ACCESSION NBR: 8202220361 DOC. DATE: 82/02/11 NOTARIZED: NO DOCKET #
 FACIL: 50-397 WPPSS Nuclear Project, Unit 2, Washington Public Power 05000397
 AUTH. NAME: BOUCHEY, G. D. AUTHOR AFFILIATION: Washington Public Power Supply System
 RECIP. NAME: SCHWENCER, A. RECIPIENT AFFILIATION: Licensing Branch 2

SUBJECT: Submits info re surveillance criteria that will be used in maint program to test second level undervoltage protective relays, in response to 820208 telcon. Table re non-class IE loads & proposed FSAR changes encl.

Subject: NUCLEAR PROJECT NO. 2
SER OPEN ITEMS, PSB ELECTRICAL

SIMPLIFIED LOGIC DIAGRAM

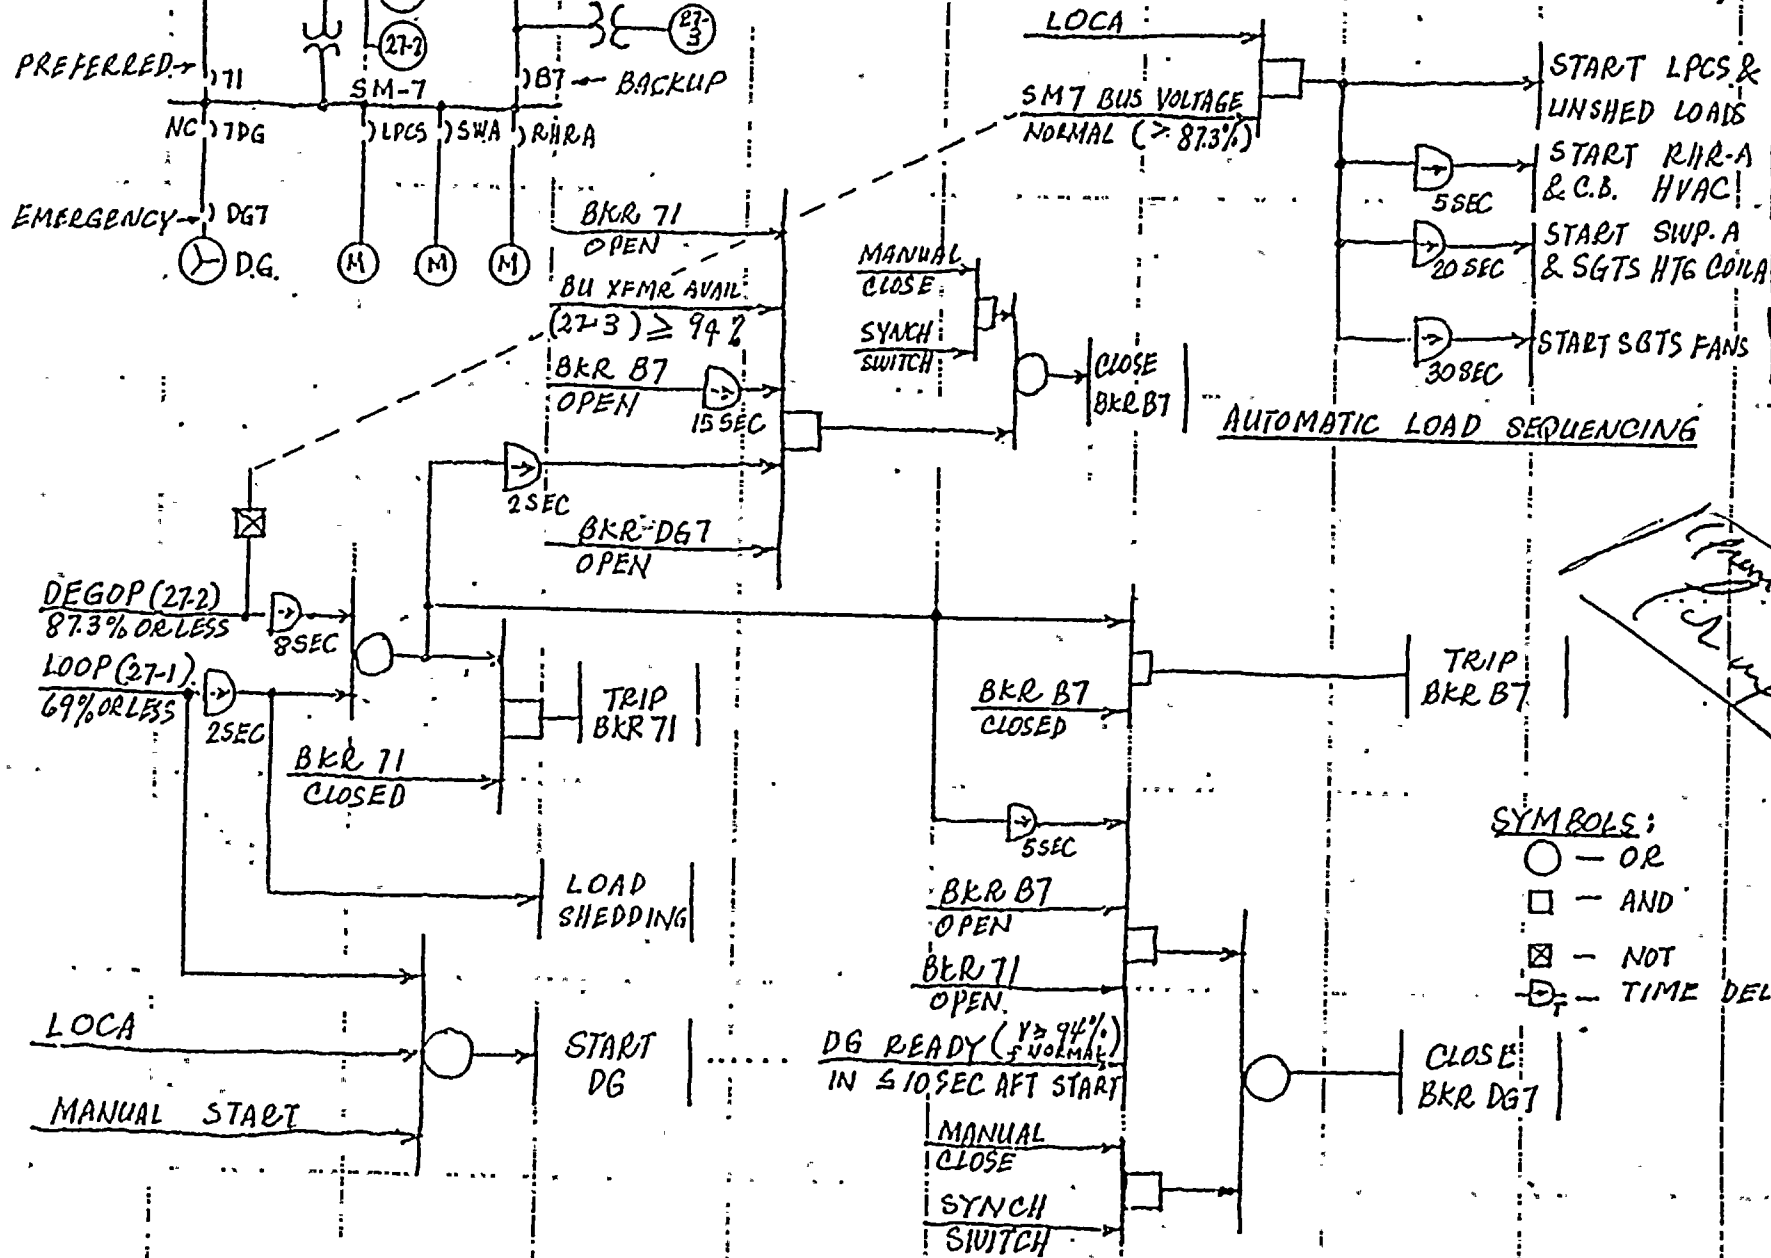
Attached is a forthcoming FSAR change which responds to the concern that the motors may not have the capability to withstand a degraded bus voltage condition for the eight (8) seconds. This change also contains a one (1) line diagram showing the logic associated with the second level under-voltage protection.

TO SHOW: PRIM & SEC UV PROTECTION; BUS TRANSFER, DG START, LOAD SHEDDING & LOAD SEQUENCING.
(OTHER PROTECTION PERMISSIVES OMITTED)

In the event of sustained bus undervoltage (87.3% of ^{nominal bus} rated voltage lasting more than 8 seconds), the second level of undervoltage protection automatically ^{trips} isolates the feeder breaker connecting the normal/startup sources to their respective 4.16 kV Class 1E buses. ^{For 1H:} This action results in loss of bus voltage, thereby, initiating load shedding and energizing the three bus transfer timers mentioned in the primary undervoltage scheme above. In this case, however, the first two-second timer is bypassed. The second two-second timer permits closing of the backup source breaker and the five-second timer permits closing of the diesel generator breaker assuming a failure of the backup source breaker to close. Closure of the backup source and diesel generator breakers is permitted if the source voltage is at least 94% of normal.

Should the degraded voltage condition exist on the backup power source while the source is supplying the load, the second level undervoltage relays would then isolate that source, again initiating the sequence of events described for the secondary undervoltage sensing scheme above. However, closing of backup feeder breakers, as part of that sequence of events, is blocked.
